| Works Approval Number | W6195/2018/1 |
| Works Approval Holder | Egan Street Rothsay Pty Ltd |
| Premises | Rothsay Gold Project Mining tenements M59/39 and M59/40 PERENJORI WA 6620 |
| Decision | Revised works approval granted |

Figure 2: Freeboard of TSF Operational Pond

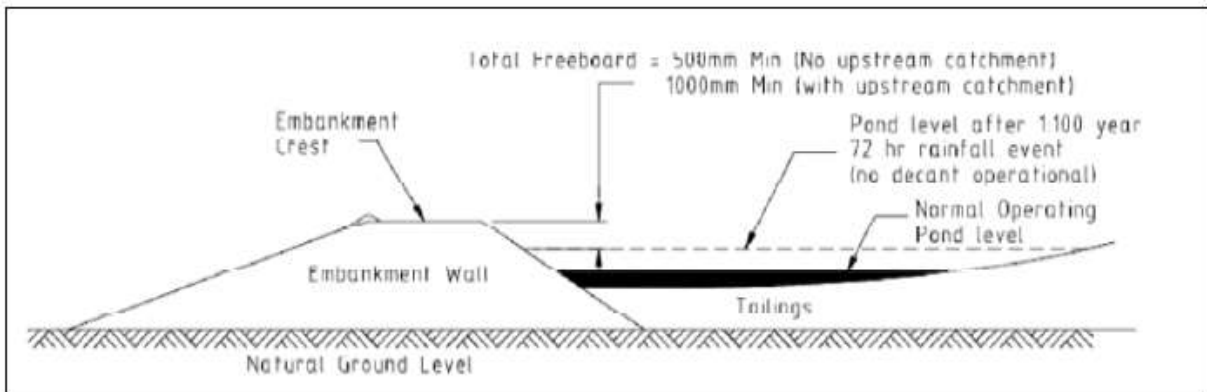
A minimum freeboard of 500mm will be maintained, following a 1 in 100 year ARI, 72 hour rainfall event, as shown in Figure 2 below.
